Great Marlborough Street, Manchester

Summary of Proposed Amendments to Consented Scheme

November 2023

First Floor Plan

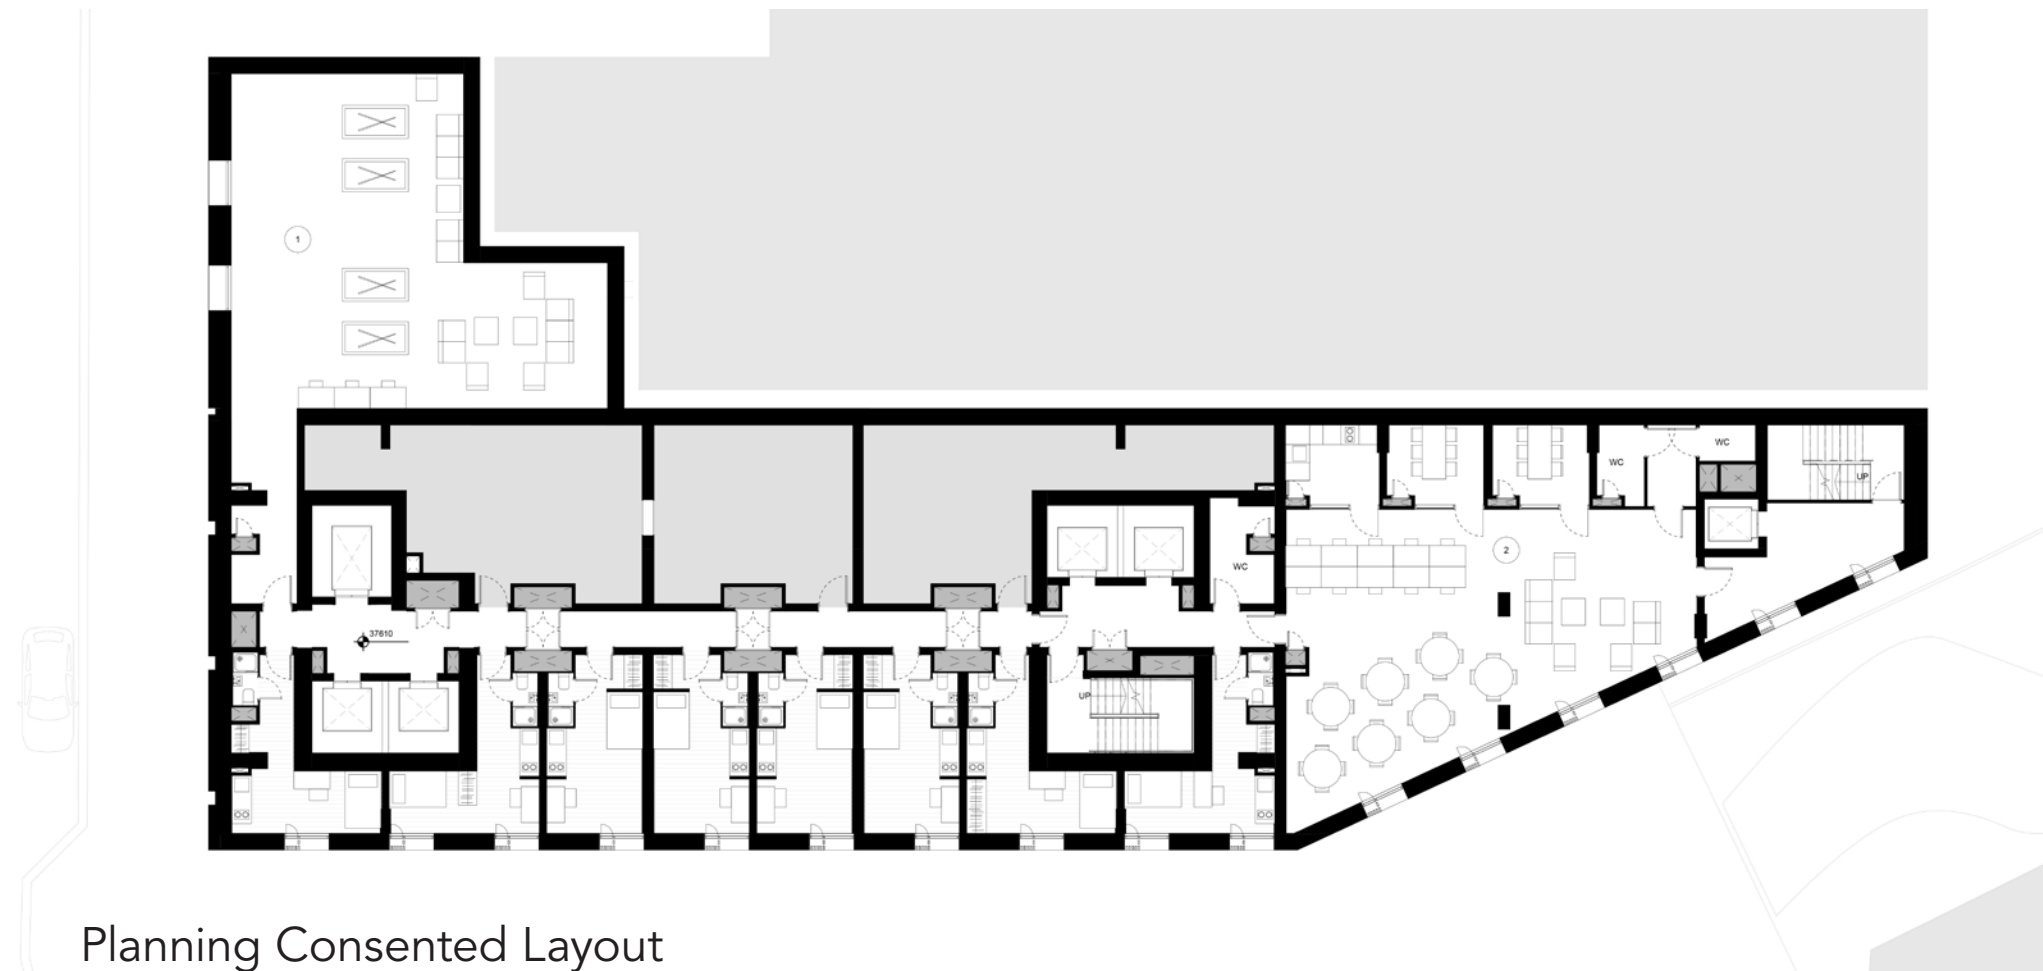
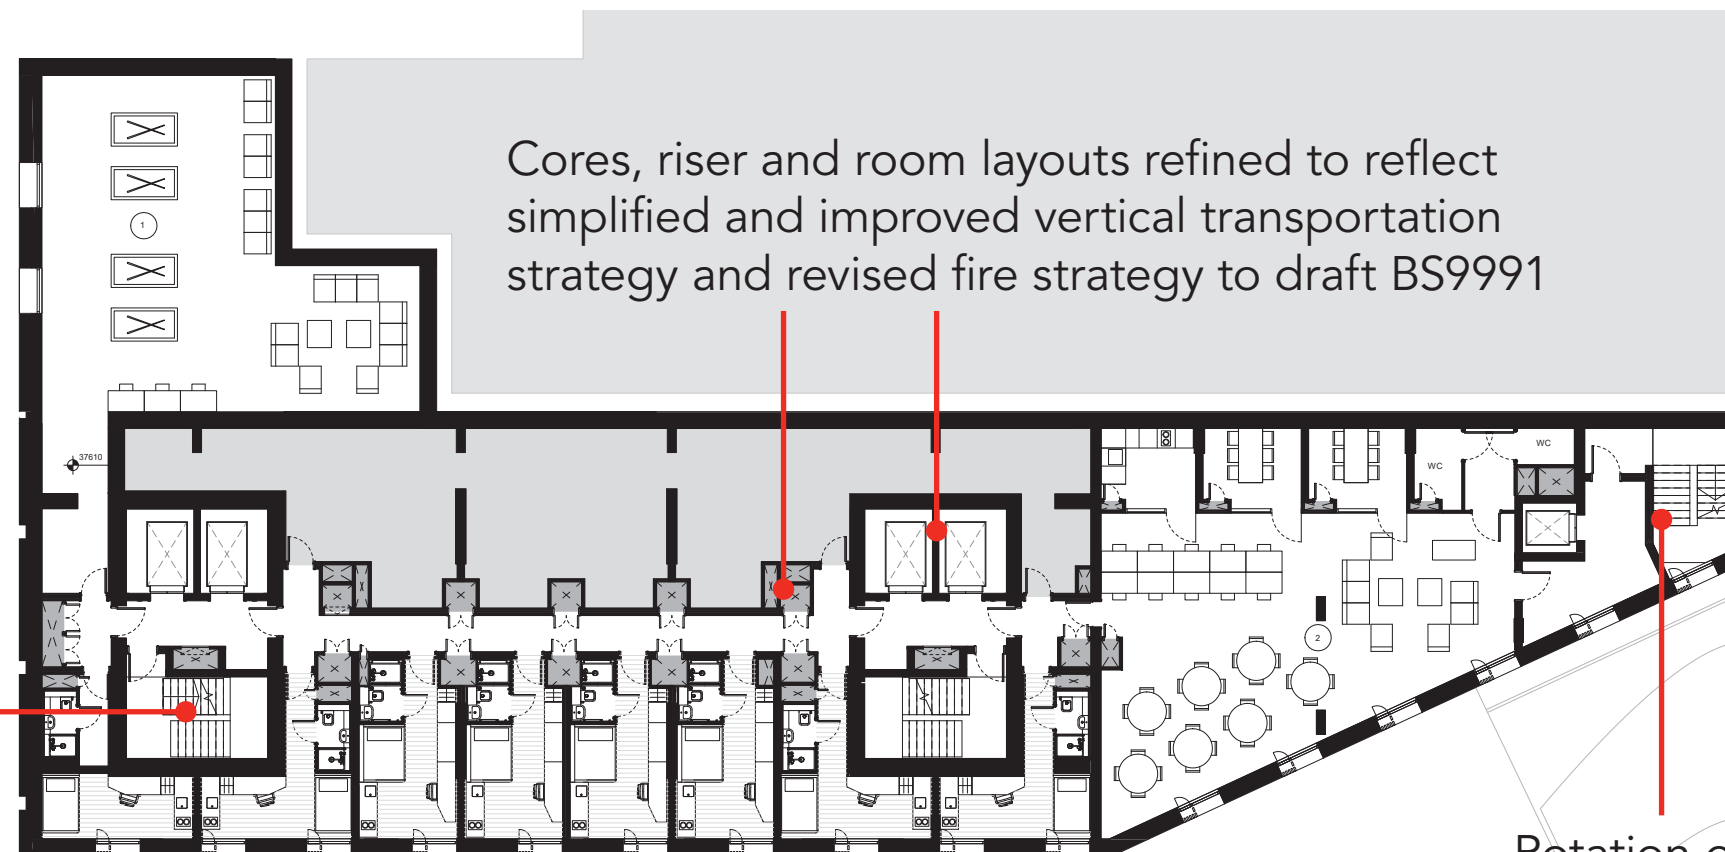
Addition of
second staircase

Rotation of
staircase

Second Floor Plan

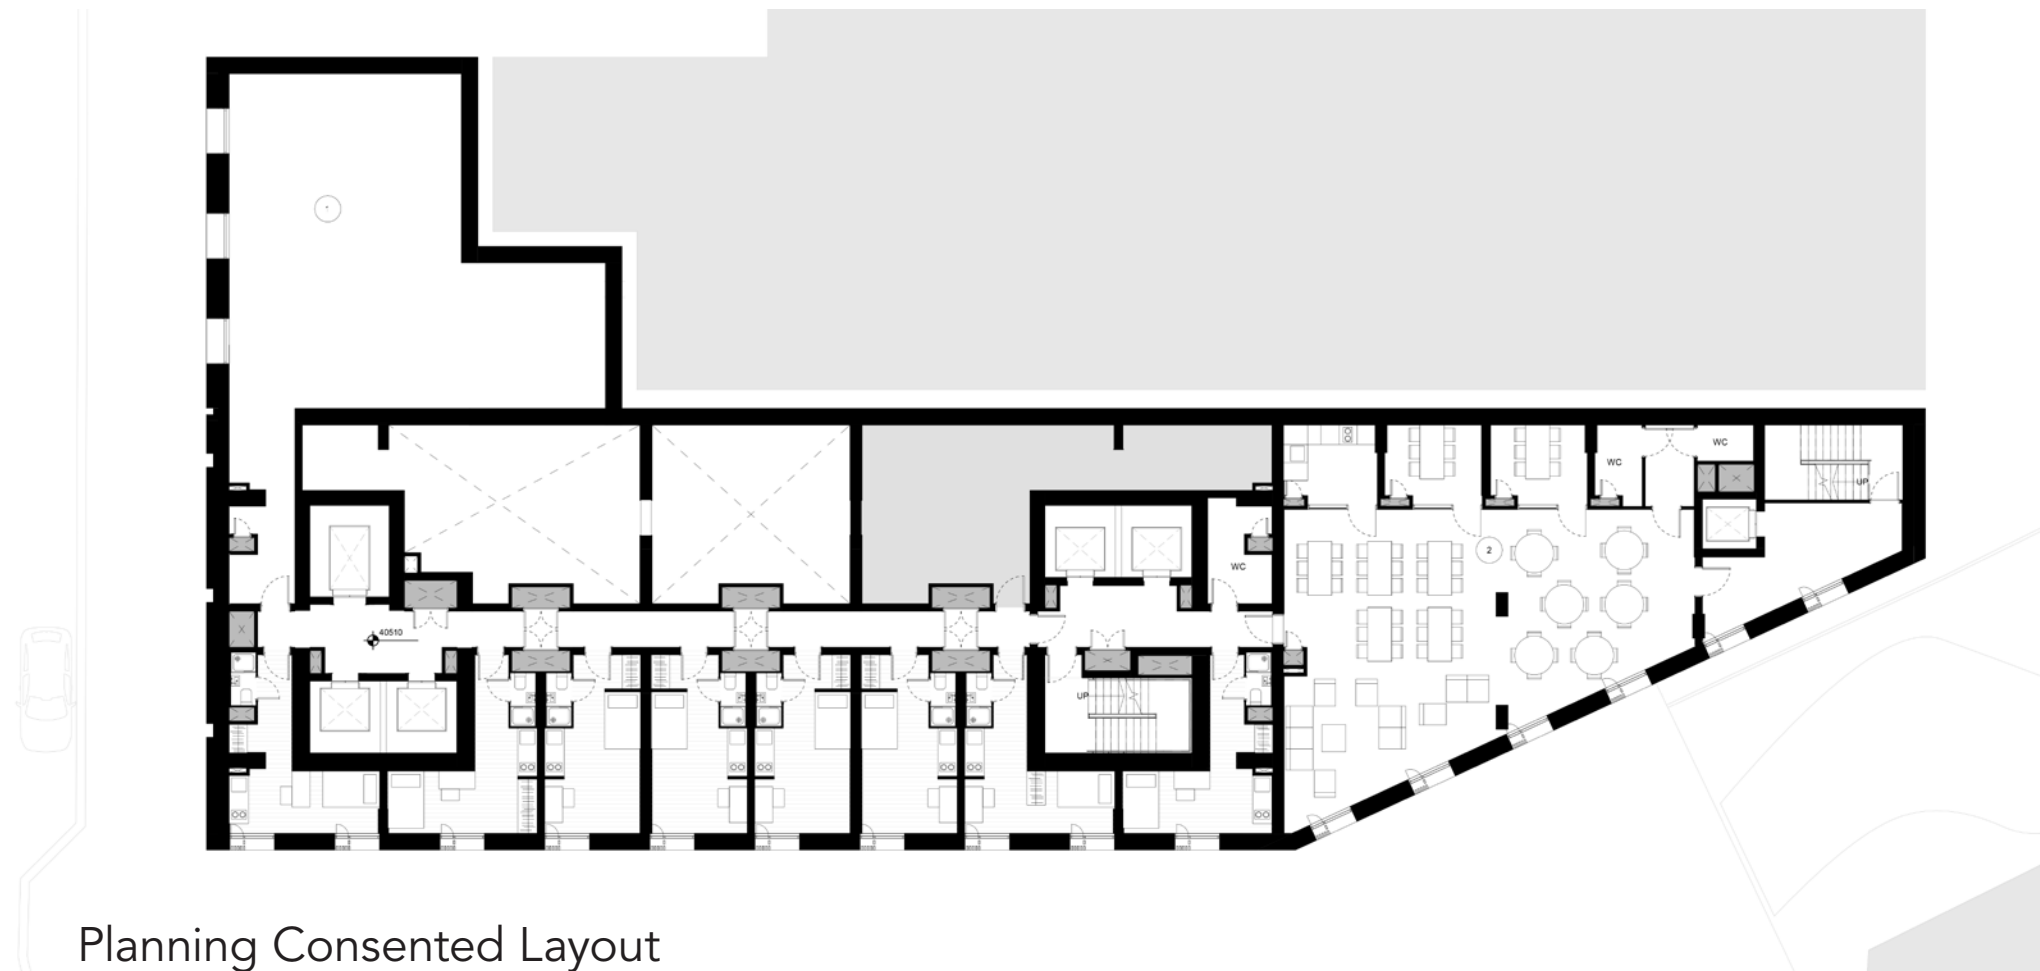
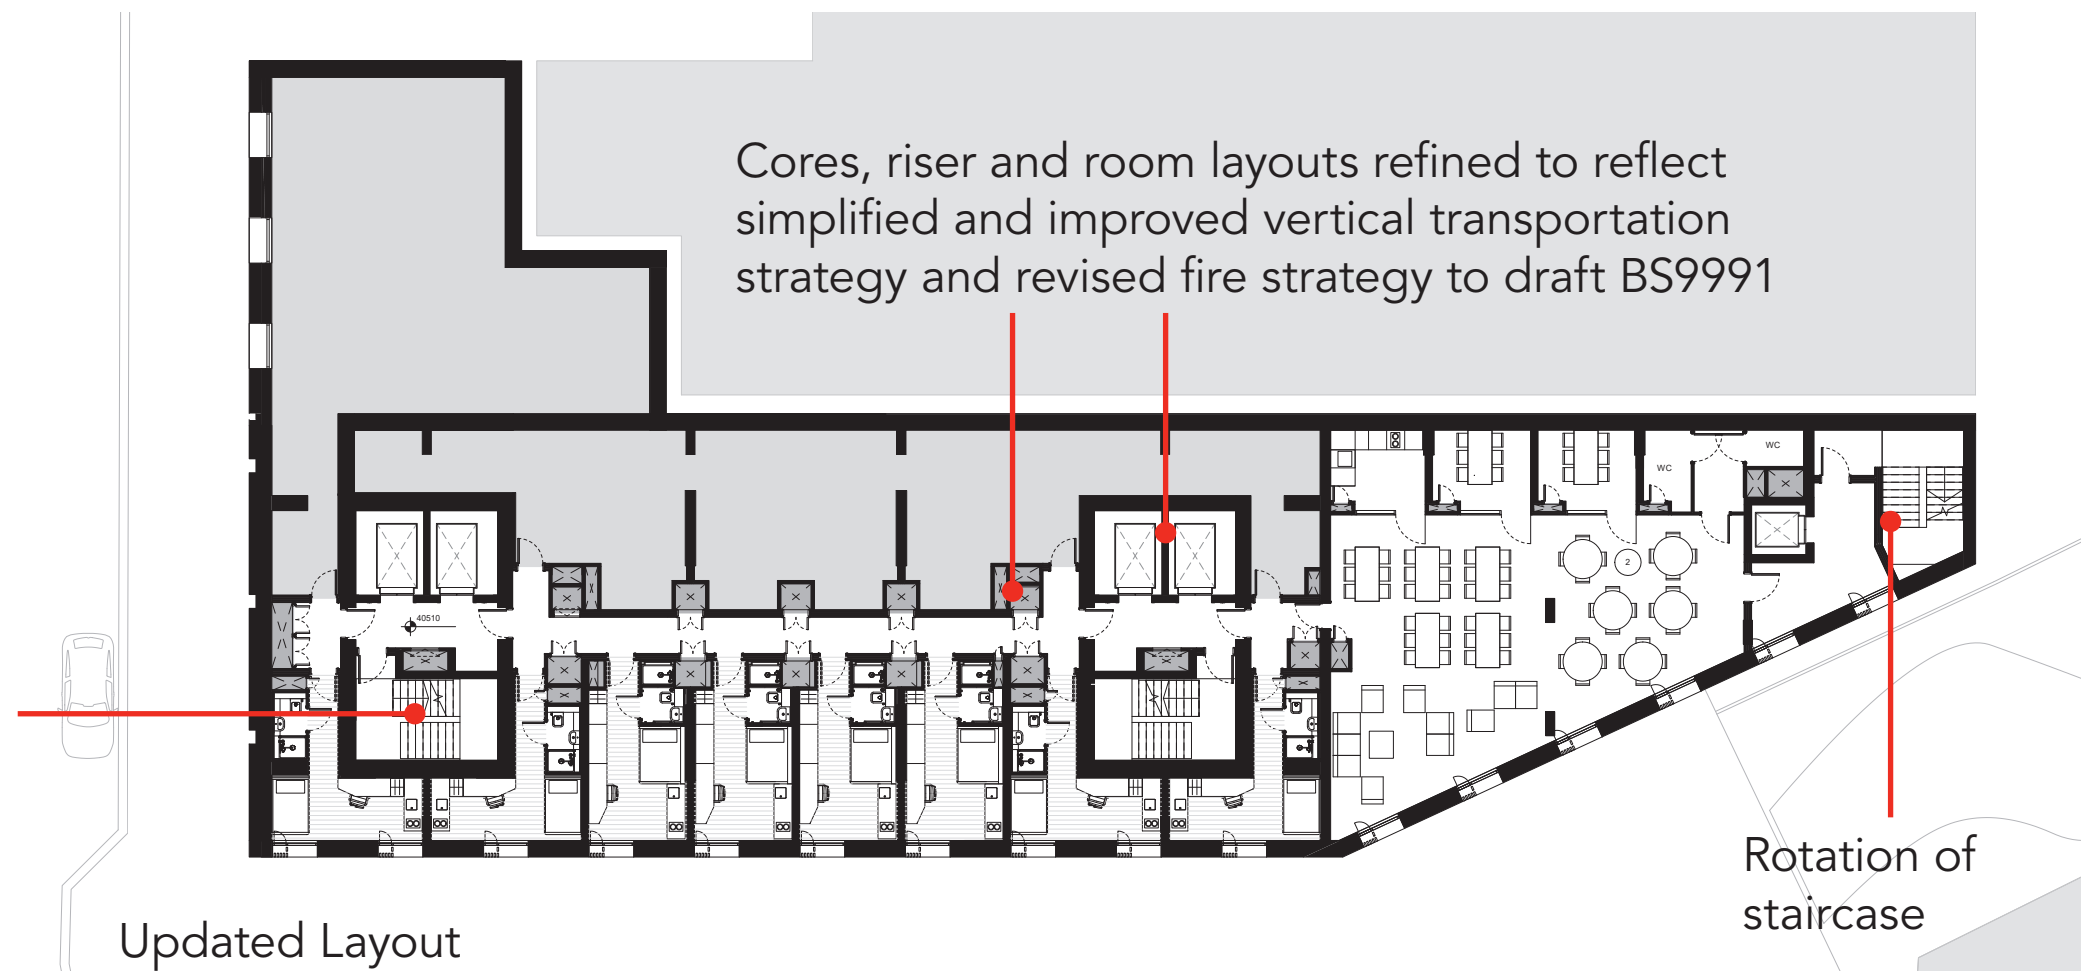
Addition of second staircase as draft Part B guidance

Rotation of staircase

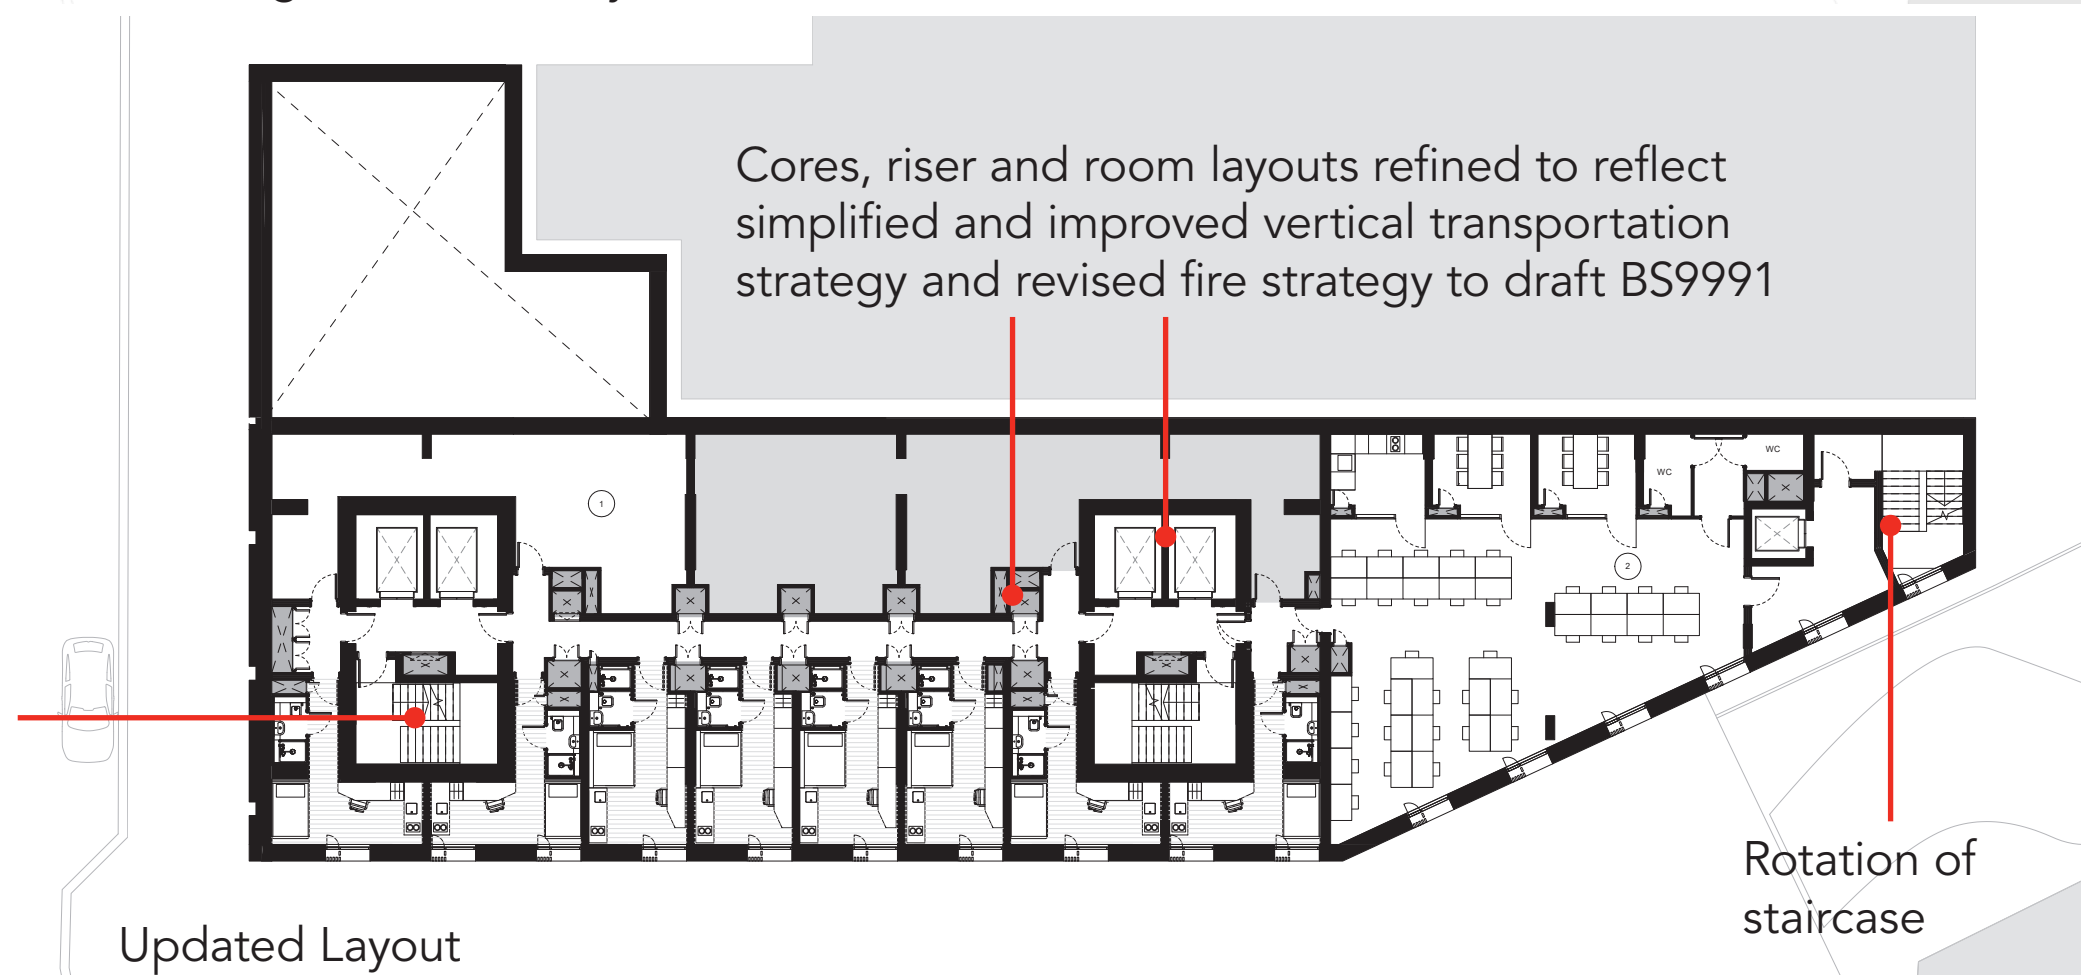
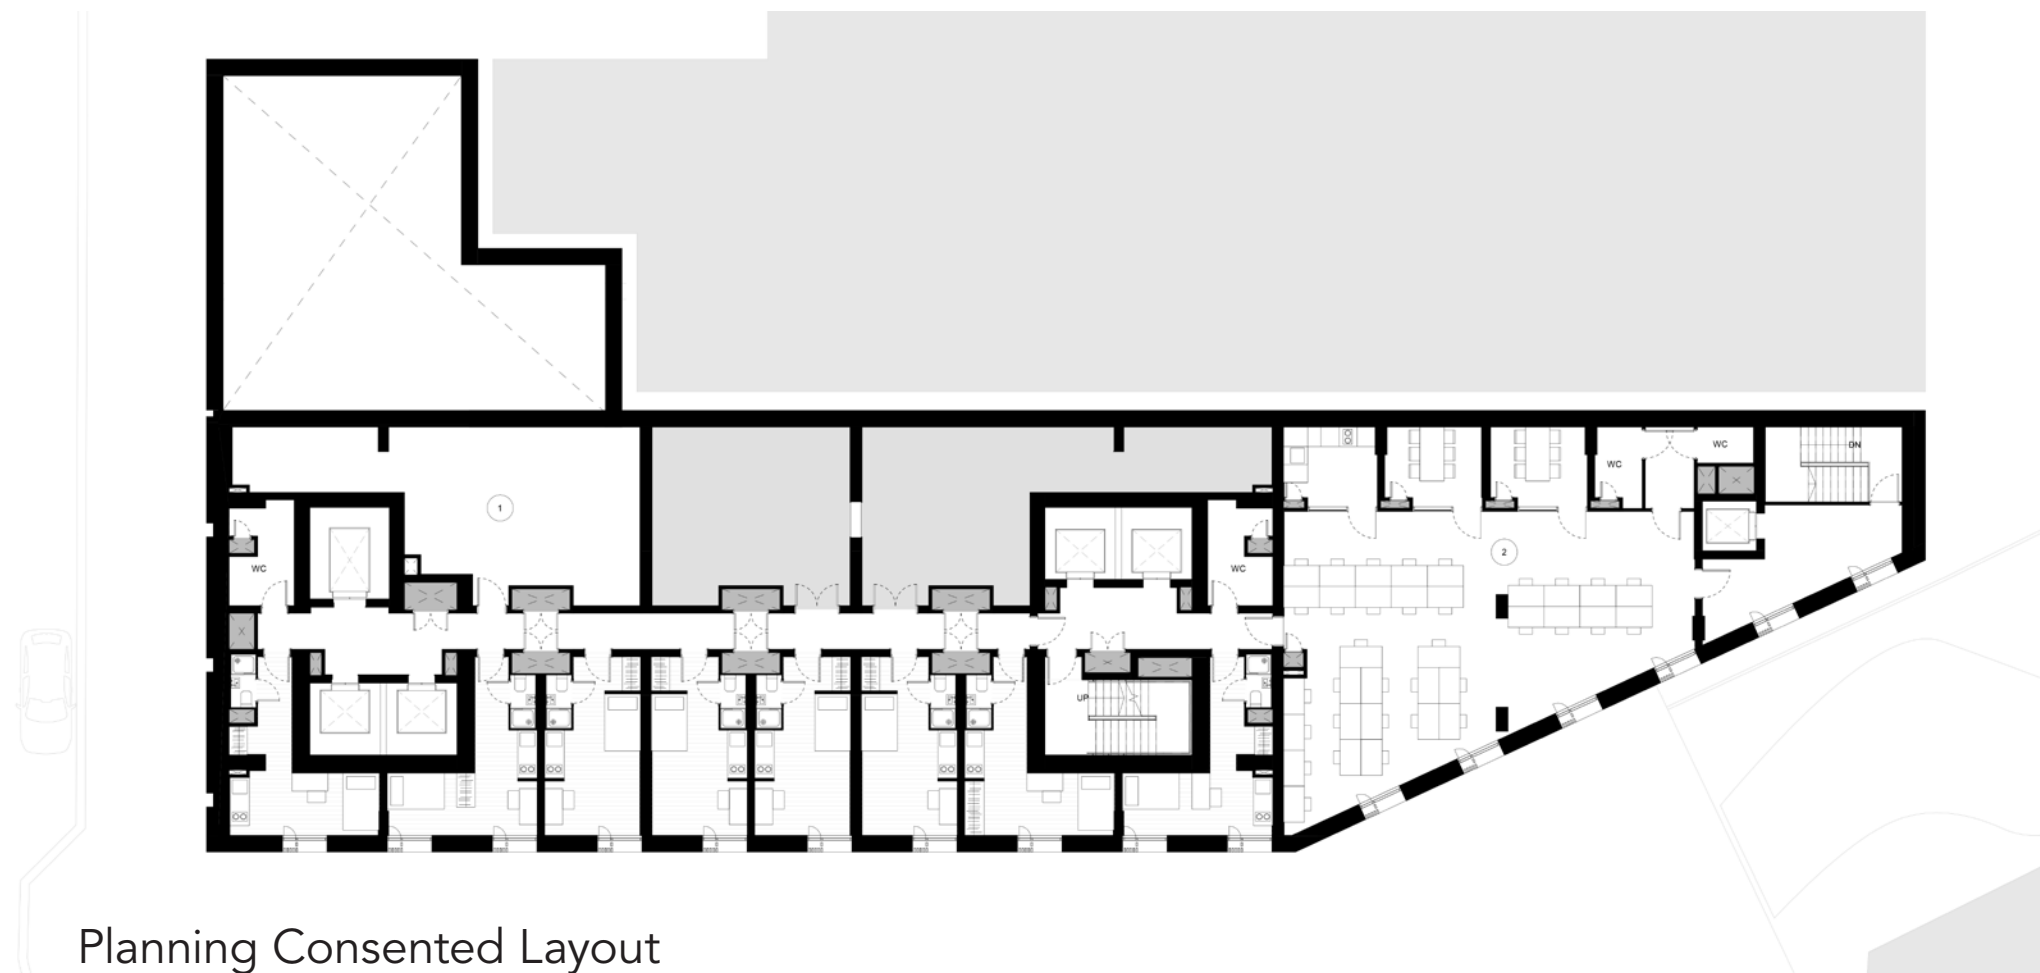
Addition of second staircase as draft Part B guidance

Rotation of staircase
